Access Compliance Report

Public Rights-of-Way

Intersection ID: N/A	Main Street: COPPER_WY	Cross Street: N/A	Location: SE
ADA ID: 5E82EB8C907C	Ramp Type: PerpDiag	Initial Pass/Fail: Fail	Overall Compliance: No
			Severity Score: 21.25

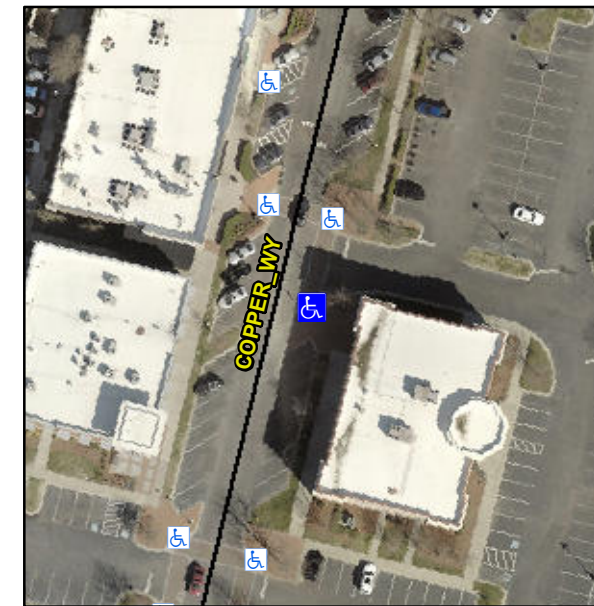
R304.5.1, R304.2.2

Compliance	Description	Data	Compliance	Description	Data
N/A	Ramp Length (in)	66.0	No	Ramp Slope (%)	9.9
No	Ramp Width (in)	44.0	Yes	Ramp XSlope (%)	0.2
N/A	Flare Type LT	N/A	N/A	Flare Type RT	N/A
N/A	Flare Slope LT (%)	N/A	N/A	Flare Slope RT (%)	N/A
N/A	Flare Traversable LT?	N/A	N/A	Flare Traversable RT?	N/A
N/A	Landing Length (in)	N/A	N/A	DWS Provided?	N/A
N/A	Landing Width (in)	N/A	N/A	DWS Contrast?	N/A
N/A	Landing Slope (%)	N/A	N/A	DWS Length (in)	N/A
N/A	Landing X Slope (%)	N/A	N/A	DWS Full Width?	N/A
N/A	Landing Curb? (Y/N)	N/A	N/A	DWS Offset (in)	N/A
N/A	Shared Landing?	N/A			
N/A	Gutter Ponding?	N/A	N/A	Gutter Slope (%)	N/A
N/A	Gutter Lip Ht (in)	N/A	N/A	Gutter X Slope (%)	N/A
N/A	Painted X Walk1?	Yes	N/A	Painted X Walk2?	No
	X Walk 1 Direction	To NE		X Walk 2 Direction	To NW
N/A	X Walk 1 Width (in)	101.0	N/A	X Walk 2 Width (in)	N/A
	X Walk 1 Slope (%)	0.0		X Walk 2 Slope (%)	0.1
	X Walk 1 X Slope (%)	1.0		X Walk 2 X Slope (%)	0.6

Remove & Replace Curb Ramp With Two New Directional Ramps or Equivalent.
